SERVICE BULLETIN

N° **139-759**

DATE: August 3, 2023

ATA 11 - ADDITIONAL MARKINGS FOR CS26 AMDT 4 KIT INSTALLATION

Figure 11

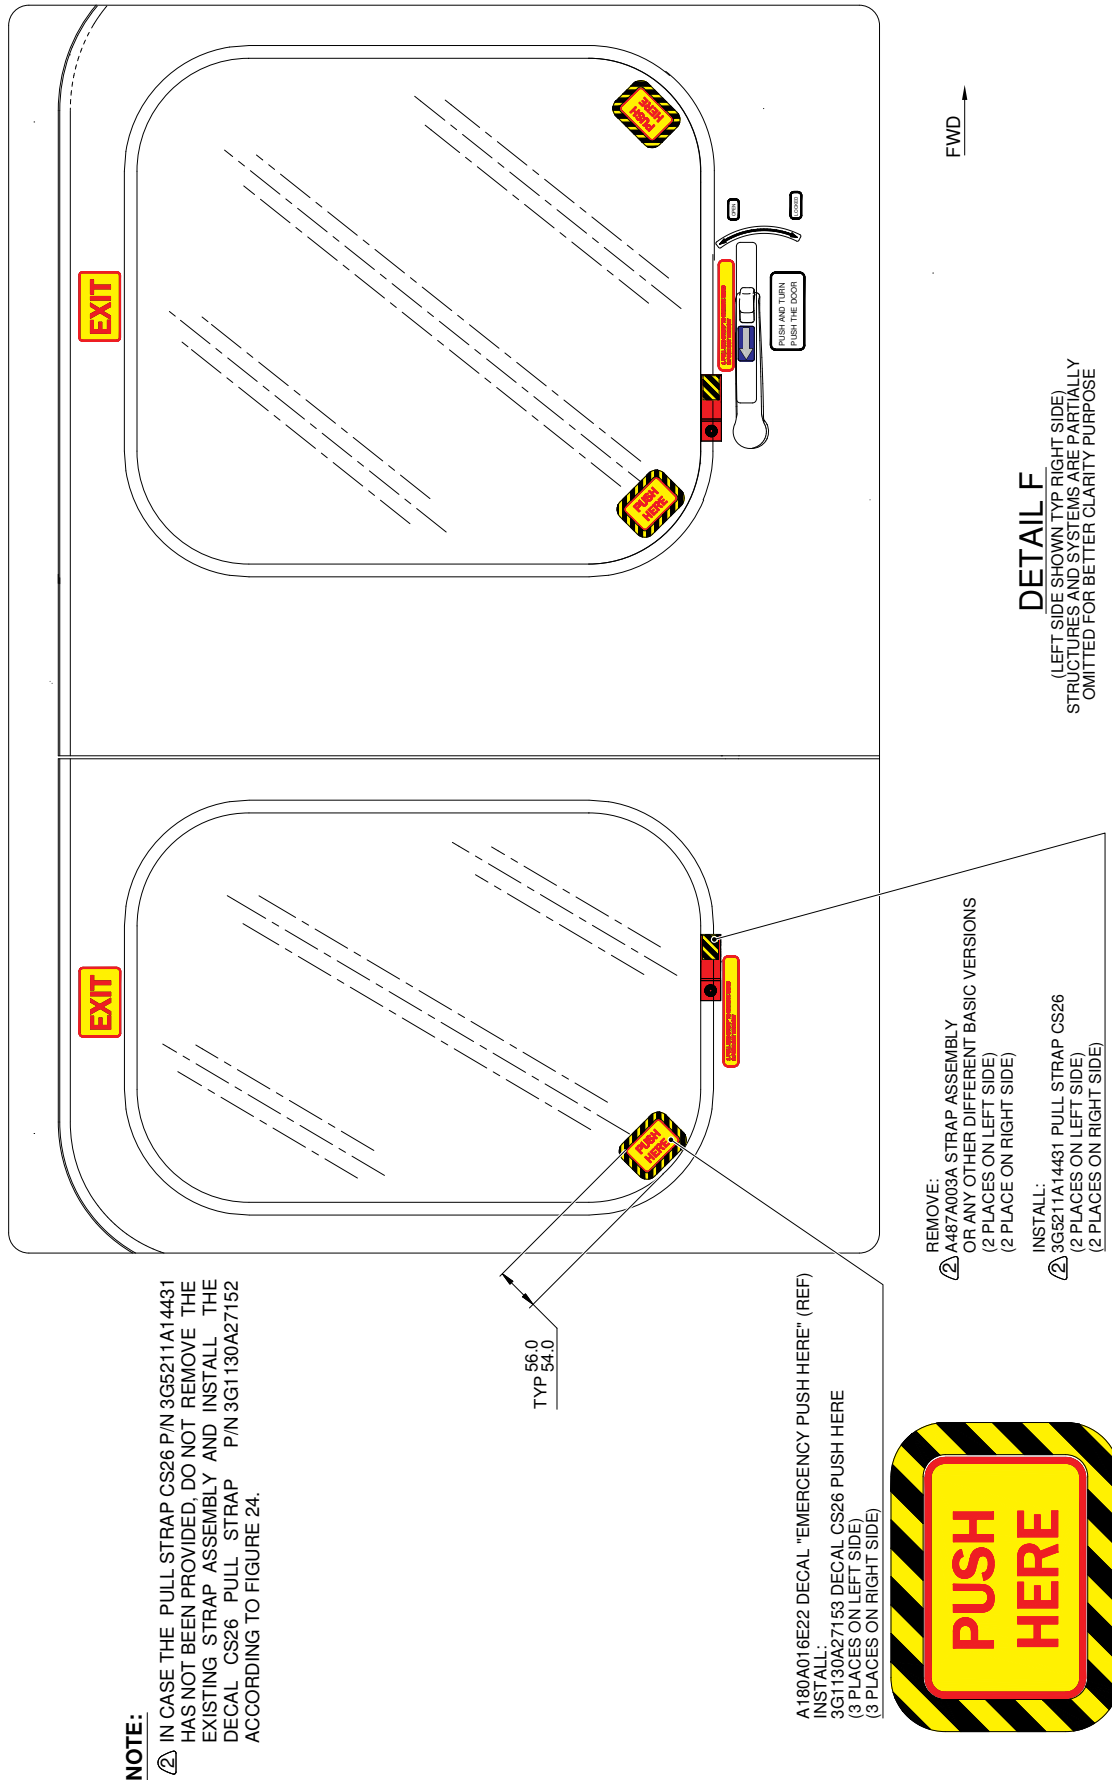
- 2.1 With reference to Figure 11 Detail F and Figure 24, sew n°2 decals CS26 pull strap P/N 3G1130A27152 by means of synthetic commercial yarn (colour red, n°31136 per FED-STD-595) on the two strap assemblies P/N A487A003A.

- 2.2 In accordance with the applicable steps of AMP DM 39-A-56-32-01-00A-920A-A or 39-A-56-32-02-00A-920A-A or 39-A-56-33-01-00A-920A-K or 39-A-56-33-02-00A-920A-K and with reference to Figure 11 Detail F, from the LH or RH cabin hinged door windows, remove n°2 strap assemblies P/N A487A003A or any other different basic version.
- 2.3 In accordance with the applicable steps of AMP DM 39-A-56-32-01-00A-920A-A or 39-A-56-32-02-00A-920A-A or 39-A-56-33-01-00A-920A-K or 39-A-56-33-02-00A-920A-K and with reference to Figure 11 Detail F, install n°2 pull straps CS26 P/N 3G5211A14431 on the LH or RH cabin hinged door windows.

- 2.4 In accordance with AMP DM 39-A-11-00-01-00A-720A-A and with reference to Figure 11 Detail F, install n°3 decals P/N 3G1130A27153 on the LH or RH cabin hinged door windows as required.

Figure 12

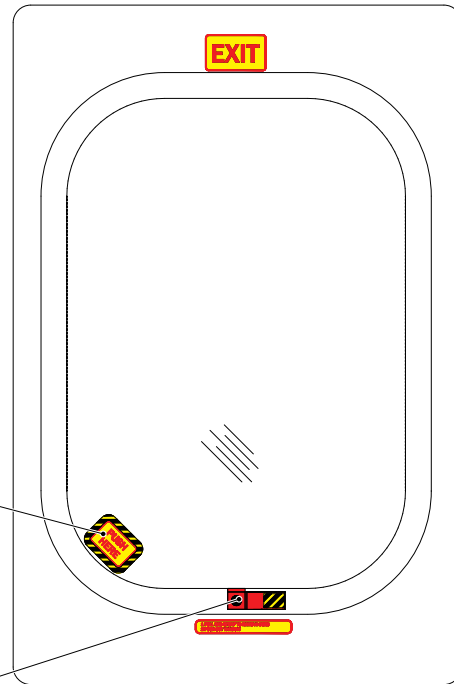
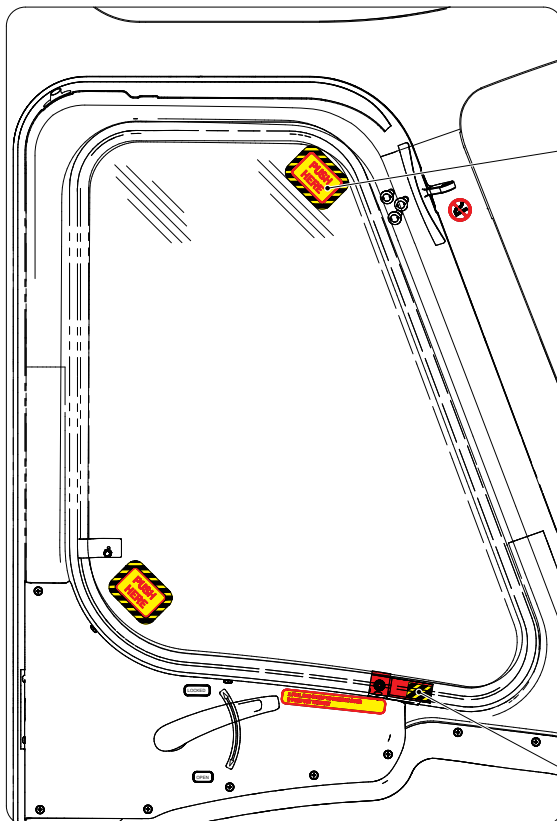
- 2.5 With reference to Figure 12 Detail G and Figure 24, sew the decal CS26 pull strap P/N 3G1130A27152 by means of synthetic commercial yarn (colour red, n°31136 per FED-STD-595) on the strap assembly P/N A487A005A.

- 2.6 In accordance with the applicable steps of AMP DM 39-A-56-21-01-00A-920A-A or 39-A-56-21-02-00A-920A-A or 39-A-56-23-01-00A-920A-K or 39-A-56-23-02-00A-920A-K and with reference to Figure 12 Detail G, from the LH or RH side wall window, remove the strap assembly P/N A487A005A or any other different basic version.
- 2.7 In accordance with the applicable steps of AMP DM 39-A-56-21-01-00A-920A-A or 39-A-56-21-02-00A-920A-A or 39-A-56-23-01-00A-920A-K or 39-A-56-23-02-00A-920A-K and with reference to Figure 12 Detail G, install the pull strap CS26 side wall P/N 3G5211A14432 on the LH or RH side wall window.

- 2.8 In accordance with AMP DM 39-A-11-00-01-00A-720A-A and with reference to Figure 12 Detail G, install the decal P/N 3G1130A27153 on the LH or RH side wall window as required.

- 2.9 With reference to Figure 12 Detail H and Figure 24, sew the decal CS26 pull strap P/N 3G1130A27152 by means of synthetic commercial yarn (colour red, n°31136 per FED-STD-595) on the strap assembly P/N A487A003A.

- 2.10 In accordance with the applicable steps of AMP DM 39-A-56-31-01-00A-920B-A or 39-B-56-31-01-00A-920A-K or 39-A-56-31-02-00A-920B-A or 39-B-56-31-02-00A-920A-K and with reference to Figure 12 Detail H, from the LH or RH cockpit door window, remove the strap assembly P/N A487A003A or any other different basic version.
- 2.11 In accordance with the applicable steps of AMP DM 39-A-56-31-01-00A-920B-A or 39-B-56-31-01-00A-920A-K or 39-A-56-31-02-00A-920B-A or 39-B-56-31-02-00A-920A-K and with reference to Figure 12 Detail H, install the pull strap CS26 P/N 3G5211A14431 on the LH or RH cockpit door window.

- 2.12 In accordance with AMP DM 39-A-11-00-01-00A-720A-A and with reference to Figure 12 Detail H, install n°2 decals P/N 3G1130A27153 on the LH or RH cockpit door window as required.
- 2.13 Repeat steps 2.1 thru 2.12 for the other side of the helicopter.
3. With reference to Figures 15 and 16, perform the external mark installation CS26 push here yellow P/N 3G1120A16811 as described in the following procedure:

Figure 14

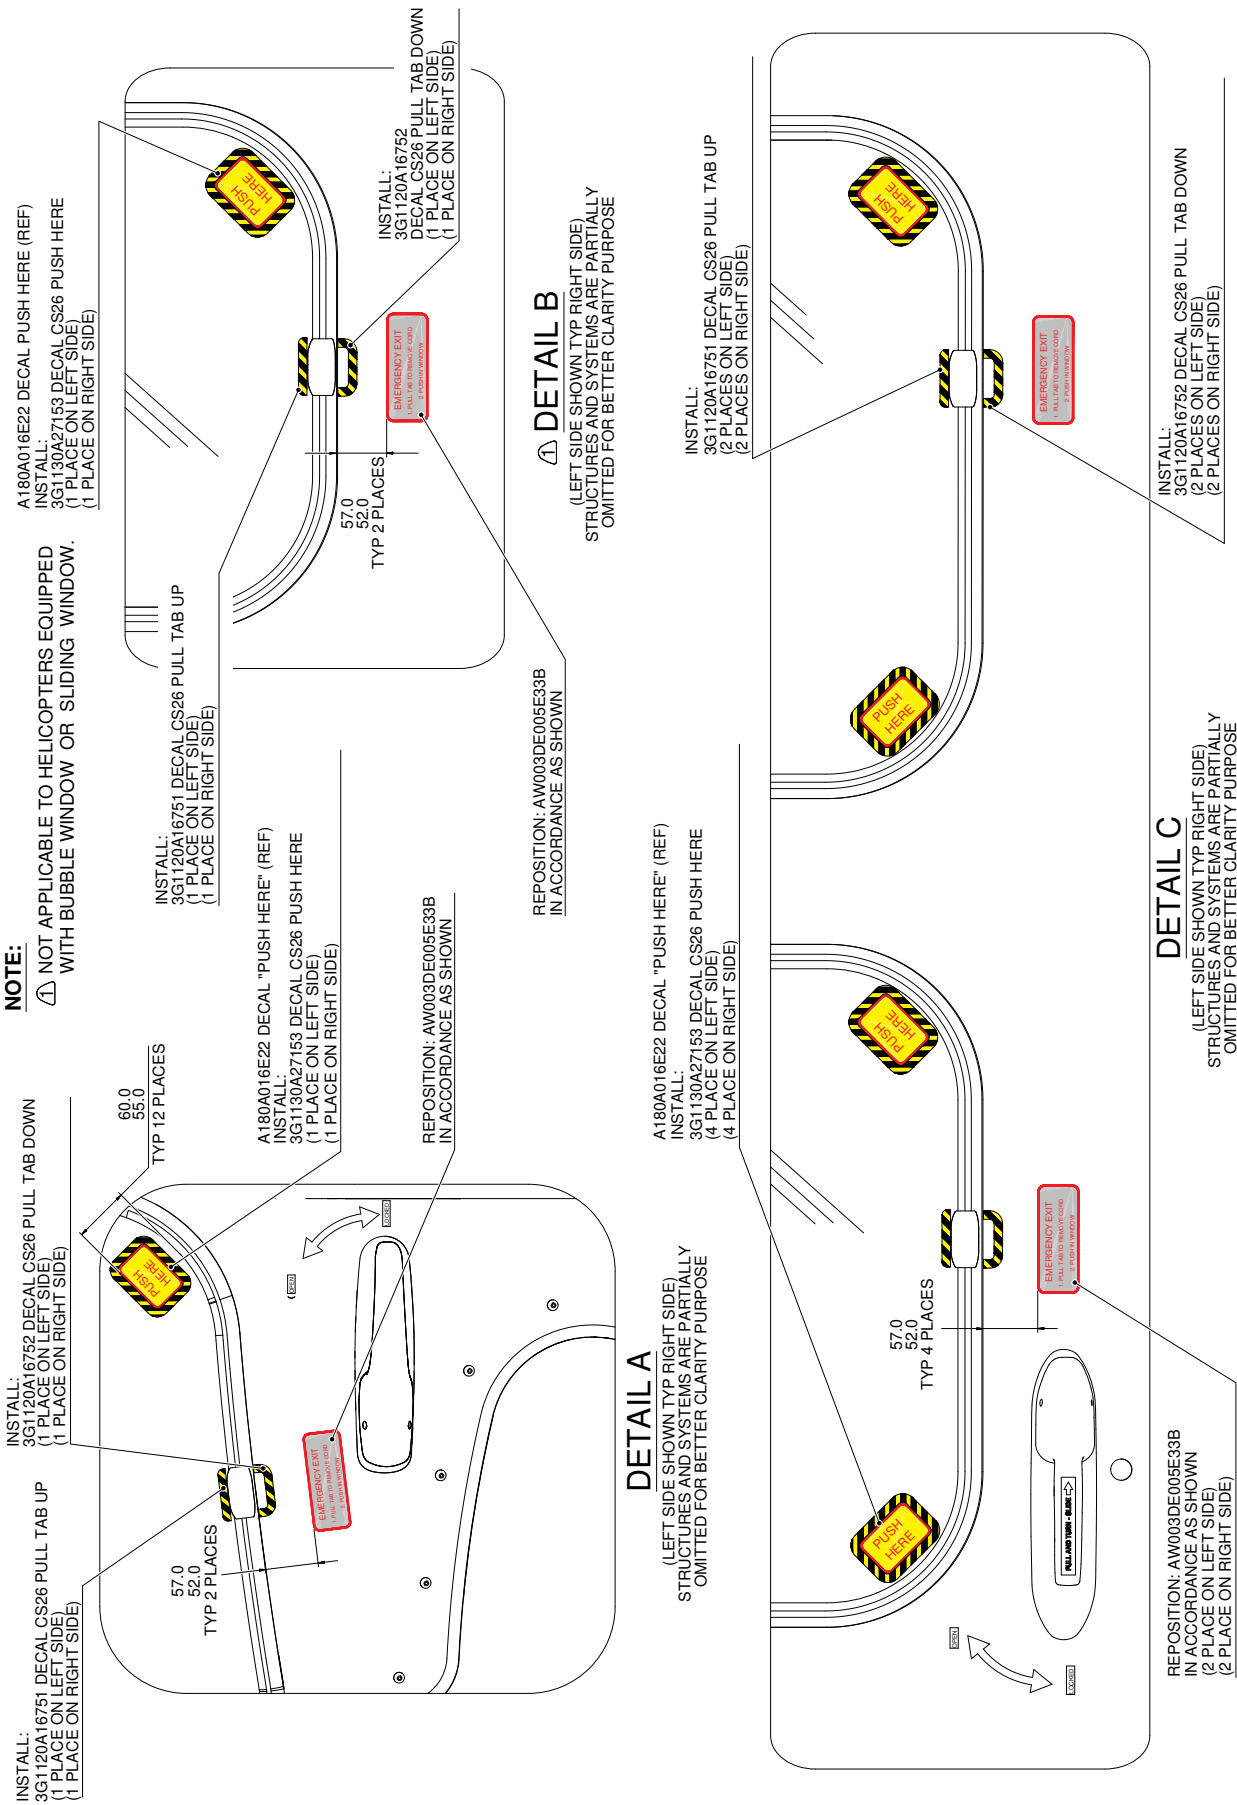
Perform the following steps 3.1 and 3.2 if it is necessary to reposition the decal P/N AW003DE005E33B on the LH or RH cockpit door (Ref. Figure 14 Detail A).

- 3.1 In accordance with AMP DM 39-A-11-00-01-00A-520A-A and with reference to Figure 14 Detail A, remove the decal P/N AW003DE005E33B from the LH or RH cockpit door.

- 3.2 In accordance with AMP DM 39-A-11-00-01-00A-720A-A and with reference to Figure 14 Detail A, install the new decal P/N AW003DE005E33B in the indicated position on the LH or RH cockpit door.
- 3.3 In accordance with AMP DM 39-A-11-00-01-00A-720A-A and with reference to Figure 14 Detail A, install the decal P/N 3G1120A16752 on the LH or RH cockpit door.
- 3.4 In accordance with AMP DM 39-A-11-00-01-00A-720A-A and with reference to Figure 14 Detail A, install the decal P/N 3G1120A16751 and the decal P/N 3G1130A27153 on the LH or RH cockpit door window.

Perform the following steps 3.5 and 3.6 if it is necessary to reposition the decal P/N AW003DE005E33B on the LH or RH side wall (Ref. Figure 14 Detail B).

- 3.5 In accordance with AMP DM 39-A-11-00-01-00A-520A-A and with reference to Figure 14 Detail B, remove the decal P/N AW003DE005E33B from the LH or RH side wall.
- 3.6 In accordance with AMP DM 39-A-11-00-01-00A-720A-A and with reference to Figure 14 Detail B, install the new decal P/N AW003DE005E33B in the indicated position on the LH or RH side wall.

- 3.7 In accordance with AMP DM 39-A-11-00-01-00A-720A-A and with reference to Figure 14 Detail B, install the decal P/N 3G1120A16752 on the LH or RH side wall.
- 3.8 In accordance with AMP DM 39-A-11-00-01-00A-720A-A and with reference to Figure 14 Detail B, install the decal P/N 3G1120A16751 and the decal P/N 3G1130A27153 on the LH or RH side wall window.

Perform the following steps 3.9 and 3.10 if it is necessary to reposition the decal P/N AW003DE005E33B on the LH or RH cabin sliding door (Ref. Figure 14 Detail C).

- 3.9 In accordance with AMP DM 39-A-11-00-01-00A-520A-A and with reference to Figure 14 Detail C, remove n°2 decals P/N AW003DE005E33B from the LH or RH cabin sliding door.

- 3.10 In accordance with AMP DM 39-A-11-00-01-00A-720A-A and with reference to Figure 14 Detail C, install the new n°2 decals P/N AW003DE005E33B in the indicated positions on the LH or RH cabin sliding door.

- 3.11 In accordance with AMP DM 39-A-11-00-01-00A-720A-A and with reference to Figure 14 Detail C, install n°2 decals P/N 3G1120A16752 on the LH or RH cabin sliding door.

- 3.12 In accordance with AMP DM 39-A-11-00-01-00A-720A-A and with reference to Figure 14 Detail C, install n°2 decals P/N 3G1120A16751 and n°4 decals P/N 3G1130A27153 on the LH or RH cabin sliding door windows.

Figure 18

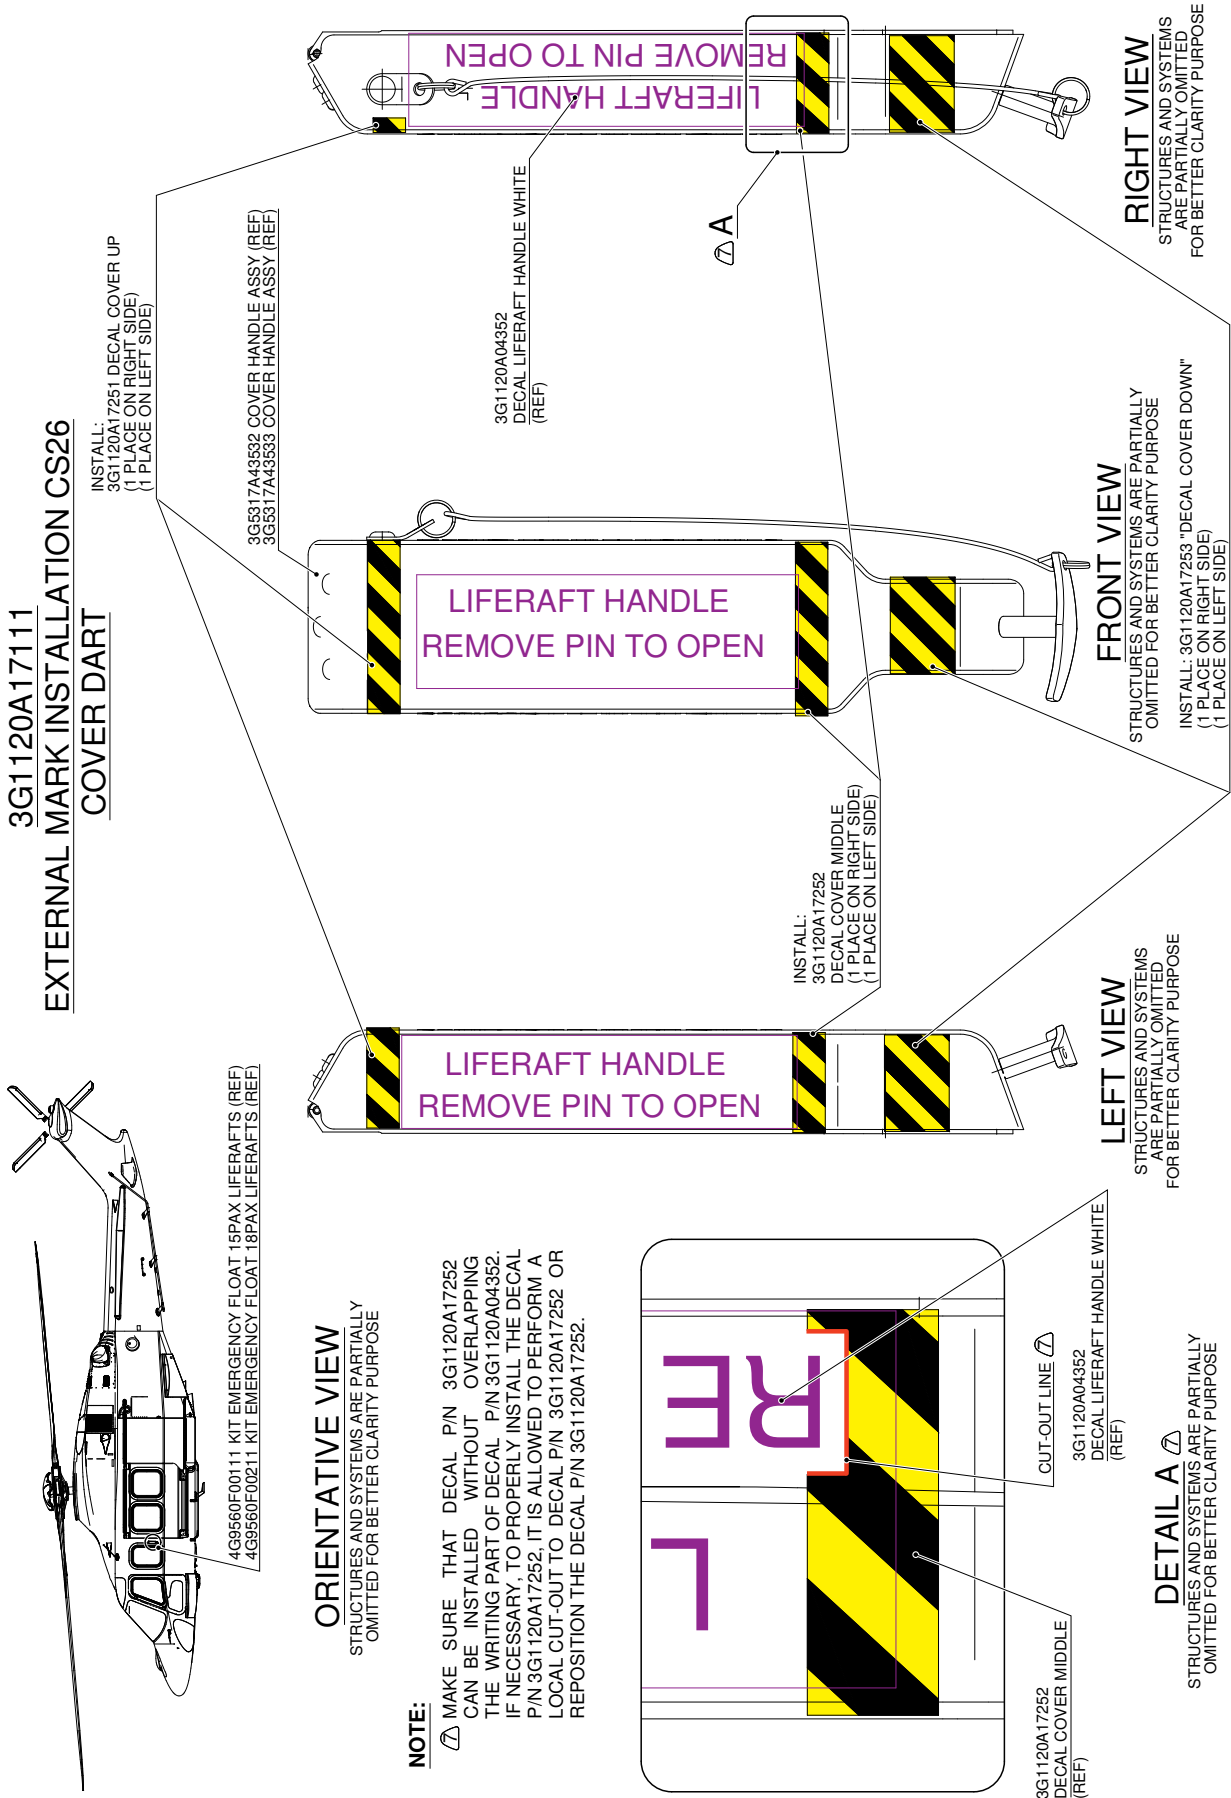
Make sure that decal P/N 3G1120A17252 can be installed without overlapping the writing part of decal P/N 3G1120A04352 (REF). If necessary, to properly install the decal P/N 3G1120A17252, with reference to Figure 18 Detail A, it is allowed to perform a local cut-out to decal P/N 3G1120A17252 or to move down the decal P/N 3G1120A17252.

2. In accordance with AMP DM 39-A-11-00-01-00A-720A-A and with reference to Figure 18 View A-A, install the decal cover up P/N 3G1120A17251, the decal cover middle P/N 3G1120A17252 and the decal cover down P/N 3G1120A17053 in the indicated positions on the cover handle assy on the LH or RH side of the helicopter.
3. Repeat step 2 for the cover handle assy on the other side of the helicopter.
4. Return the helicopter to flight configuration and record for compliance with Part VI of this Service Bulletin on the helicopter logbook.
5. Gain access to My Communications section on Leonardo WebPortal and compile the "Service Bulletin Application Communication".

Figure 24

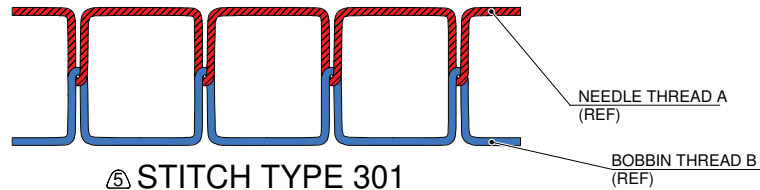
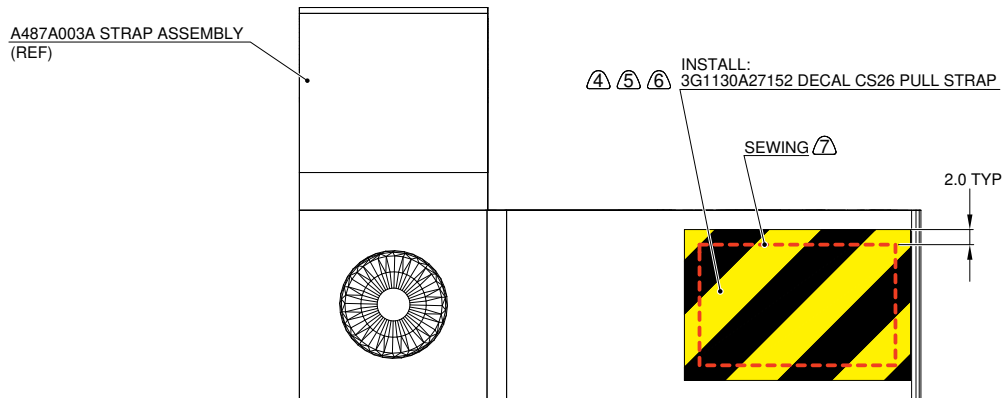
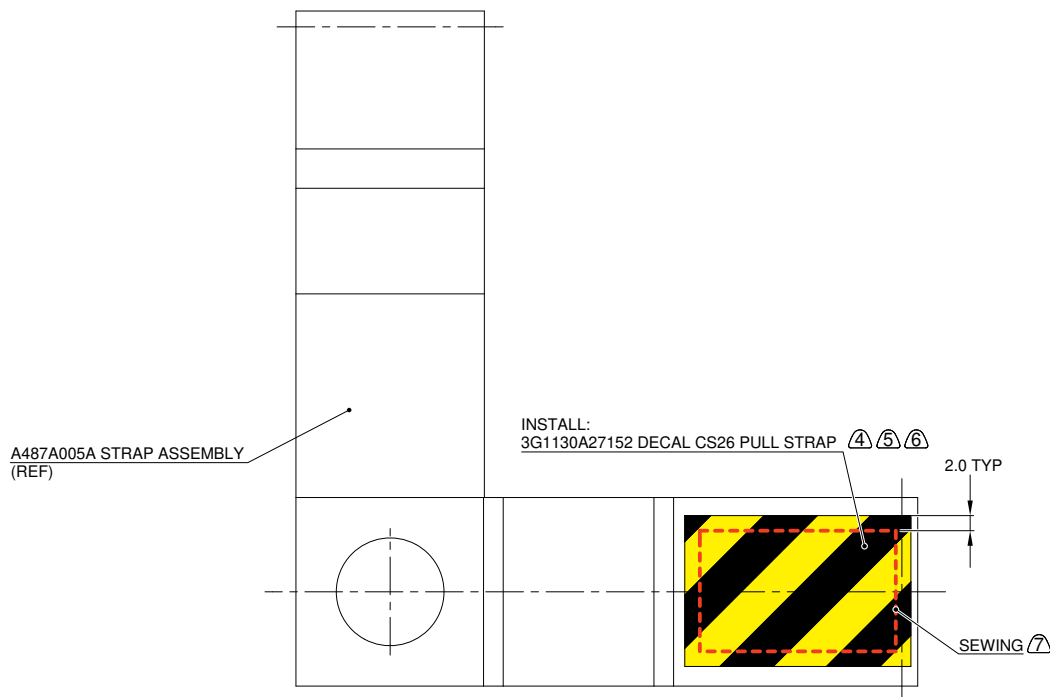
All sewing must be done in accordance with the specification ASTM D6193 type 301, from 6 to 8 stitches every 25 mm (Ref. Figure 24).

- ④ YARN, SYNTHETIC COMMERCIAL (8,0 KG MINIMUM BREAKING LOAD).
COLOUR RED, No 31136 PER FED-STD-595.
- ⑤ ALL SEWING MUST BE DONE IN ACCORDANCE WITH THE SPECIFICATION
ASTM D6193 TYPE 301, FROM 6 TO 8 STITCHES EVERY 25 mm.
- ⑥ INSTALL ON THE VISIBLE SIDE.
- ⑦ SEW ACCORDING TO THE SCHEME INDICATED.

THIS TYPE OF STITCH SHALL BE FORMED WITH TWO THREADS: ONE NEEDLE THREAD, A, AND ONE BOBBIN THREAD, B. A LOOP OF THREAD A SHALL BE PASSED THROUGH THE MATERIAL AND INTERLACED WITH THREAD B. THREAD A SHALL BE PULLED BACK SO THAT THE INTERLACING SHALL BE MIDWAY BETWEEN THE SURFACES OF THE MATERIALS BEING SEWN.
